NARRABRI GAS PROJECT

Groundwater Management Plan

PHASE 1

0041-150-PLA-0015

Figure 5.1 - Existing and Phase 1 water production forecast

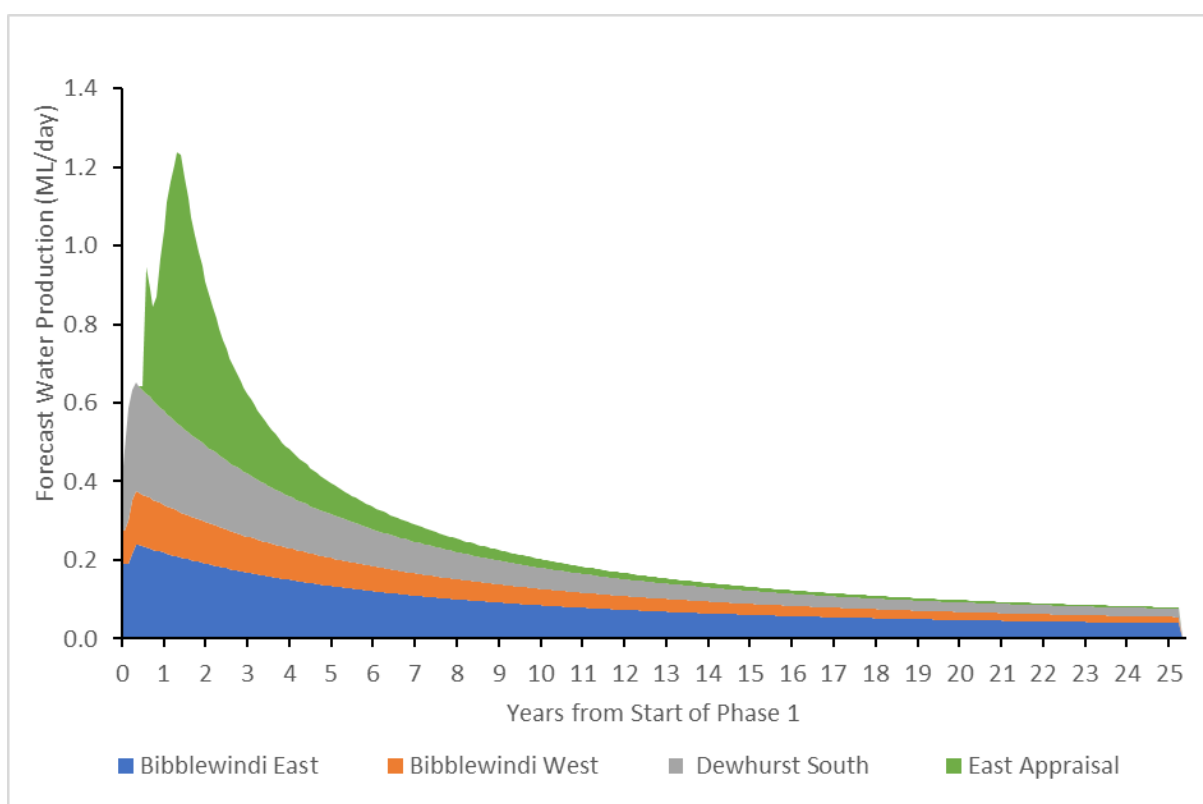
16	4.4.4	Natural methane leaks and accumulations		██████████ First para – should 'WBR' be 'GBR'	The correction has been made and the rest of the document checked for similar errors.
17	5.1	Groundwater extraction		██████████ On page 30 of this Plan there is Figure 5.1 Existing and Phase 1 water production forecast. This Figure has been presented elsewhere. The time frame for Phase 1 is from Year 0 to Year 10. However, on page 6 of the Groundwater Modelling Plan, Figure 3.1 represents a timeframe for Phase 1 from Year 0 to Year 25. Should there be more clarity in the timeframe for Phase 1 of the Project?	The text in section 5.1 has been amended as follows: <i>The model used to determine the potential groundwater impact from the Phase 1 operation was conservatively based on a 25-year operational life for the Phase 1 wells.</i> Figure 5.1 has been replaced with Figure 3.1 from the GModP.
18	5.1	Groundwater extraction	The predicted take of water from coal seams for Phase 1 of the NGP is shown in Figure 5.1.	██████████ The text and the figure label refer to water forecast for Phase 1. More correctly the data is total water forecast from wells constructed during Phase 1, over the full life of those wells.	Text in Section 5.1 has been amended as follows: <i>The predicted total water take from wells constructed prior to Phase 1 of the NGP, over the full gas production life of those wells, is shown in Figure 5.1</i>

Figure 8.1 - Monitoring points against which trigger levels have been applied

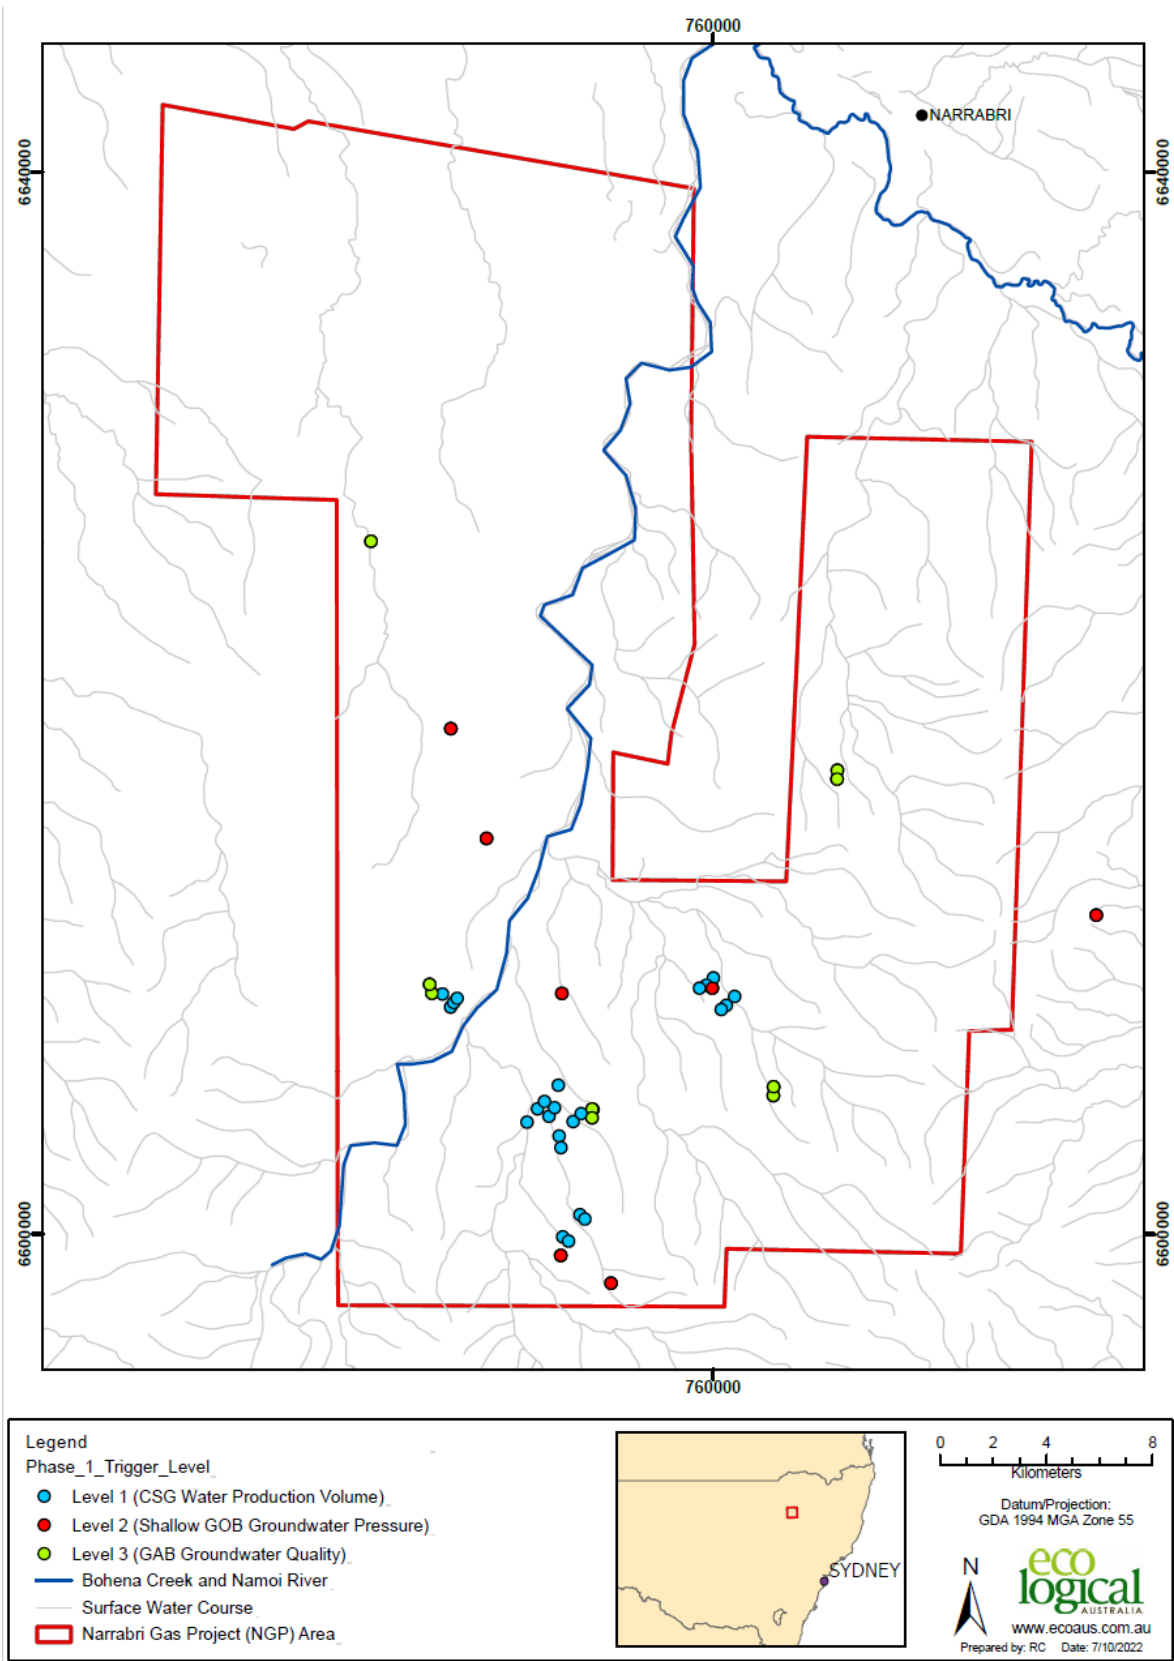
35	8.4.2	Level 2 trigger		<p>Second bottom para p44. Refers to site 'BHNS1'. Figure 8.1 shows the location of site 'BHN1S' One of the references must be incorrect</p>	The correction has been made. The well reference should be BHN1S.
36	8.4.2	Level 2 trigger		<p>On page 44 second last paragraph. Should Sites "BHNS1" actually be "BHN1S"?</p>	Refer to comment above.
37	8.5	Trigger response		<p>Second para refers to 'GMonP' – should it be 'GModP'</p>	The correction has been made.

Figure 2.1 - Baseline monitoring locations in Alluvial Groundwater Sources

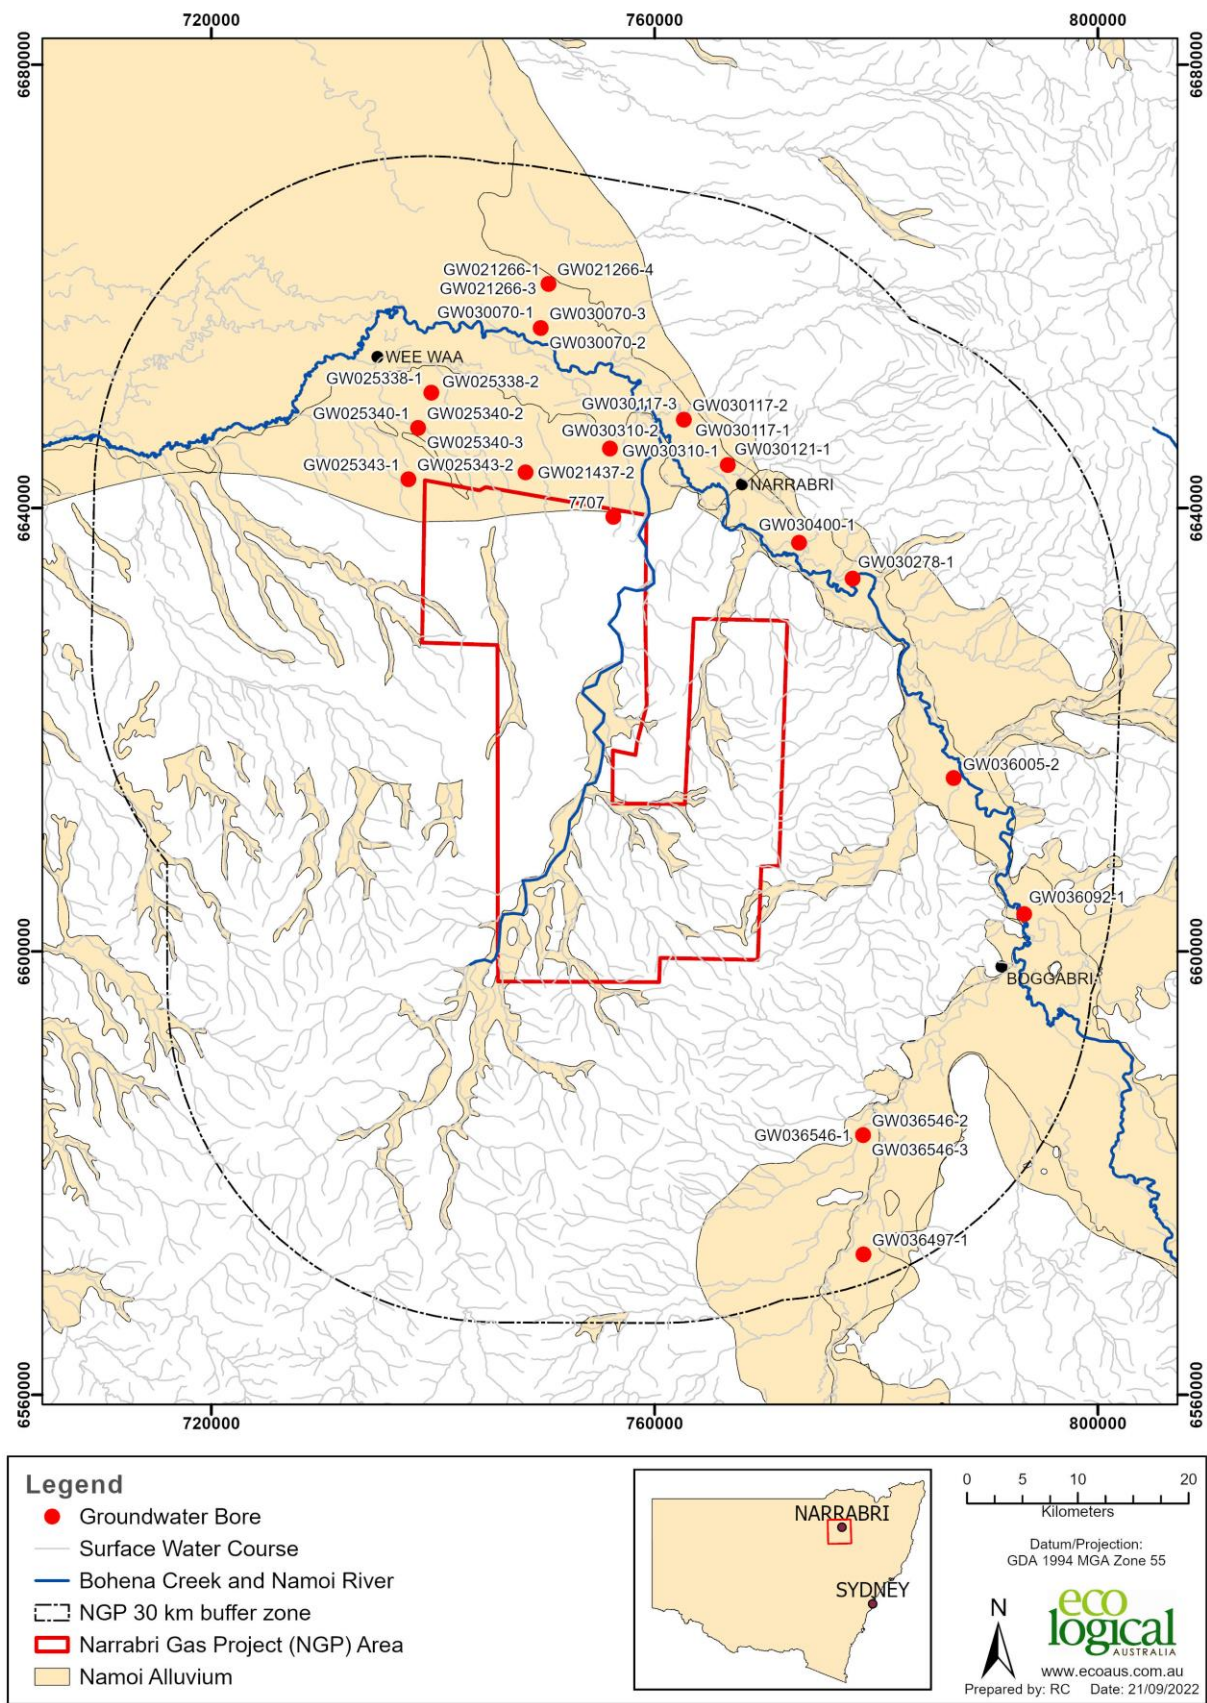
11	2.1	Private landholder bores	Figure 2.1 - Baseline monitoring locations in Alluvial Groundwater Sources	<p>It is difficult to conceptualise the Narrabri Gas Project having a measurable impact on the Upper Namoi or Cox's Creek alluvium.</p>	Noted. No response required.
12	2.1	Private landholder bores	Figures 2.1 to 2.3	<p>While the figures are correct, it is confusing as the terms that govern the geographic distribution are being mixed.</p> <p>Section 1 are water sources and section 2 are hydrostratigraphic units. It would be clearer if the Figure titles in Section 2 removed the term "groundwater sources".</p>	<p>Tables 2.1 and 2.2. link the hydrostratigraphic units described in Section 2 to the Water sources described in Section1 and the titles of Figures 2.1 to 2.3.</p> <p>Table headings have been changed to reflect this.</p>
13	3 Appendix A	Groundwater baseline data – pressure and levels		<p>I had a difficulty relating the plots in Appendix A to the text in section 3. It would help if Appendix A was structured into geologic units to match the way Table 3.1 is structured.</p>	<p>The plots in Appendix A provide the same data as that in Table 3.1, with Table 3.1 structured into geologic units to assist interpretation.</p> <p>The sequence of the plots in Appendix A has been amended to follow the structure of Table 3.1.</p>

Figure 3.1 - Phase 1 annual water production forecast

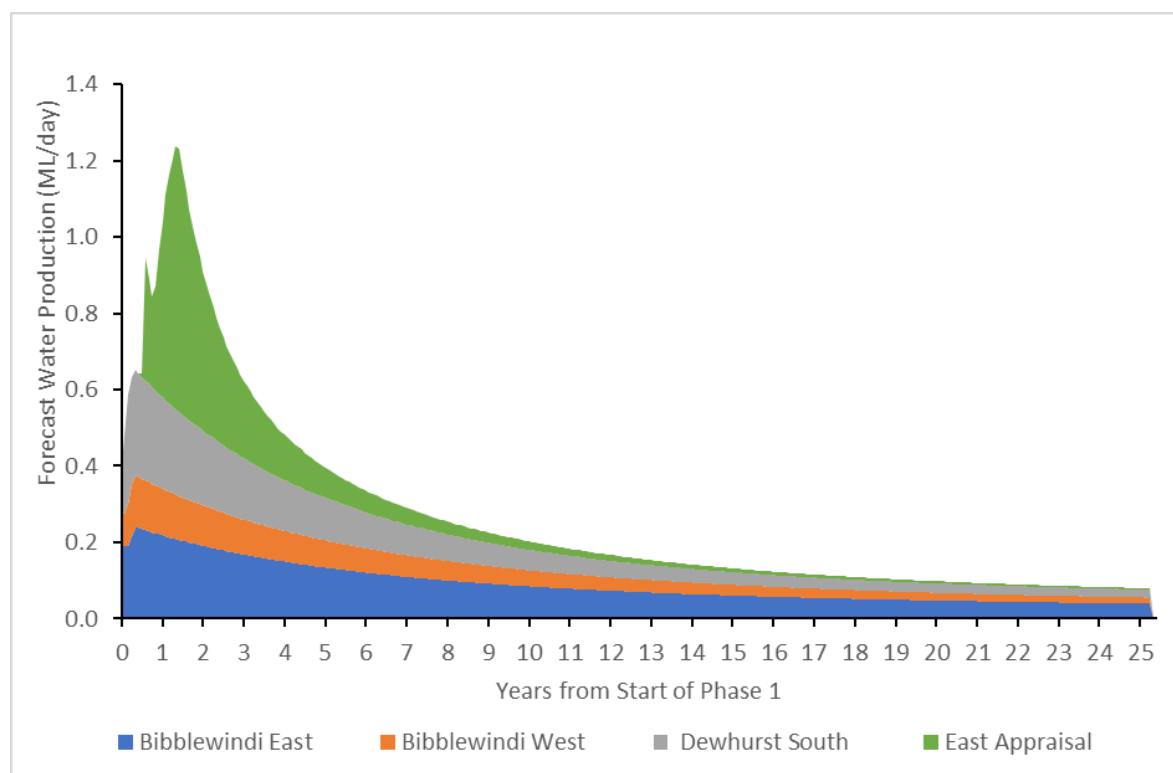
8	3.2	Phase 1 method statement	No specific text reference.	<p>██████████</p> <p>As referenced elsewhere, the dates represented in Figure 3.1 Phase 1 annual water production forecast refer to 0 to 25 years from start of Phase 1, whereas other references are made to 0 to 10 years for Phase 1. Could the period of time for Phase 1 be clarified?</p>	In line with the revised text in section 5.1 of the GMP, the text in section 3.2 has been amended as follows: <i>The model used to determine the potential groundwater impact from the Phase 1 operation was conservatively based on a 25-year operational life for the Phase 1 wells. The Model was updated with the Phase 1 annual water production forecast as shown in Figure 3.1. The forecasted water production is 2.9 gigalitres (GL) over the a period of 25 year period with an expected production peak up to 1.26 megalitres (ML) per day (ML/day) approximately two years from the start of Phase 1.</i>
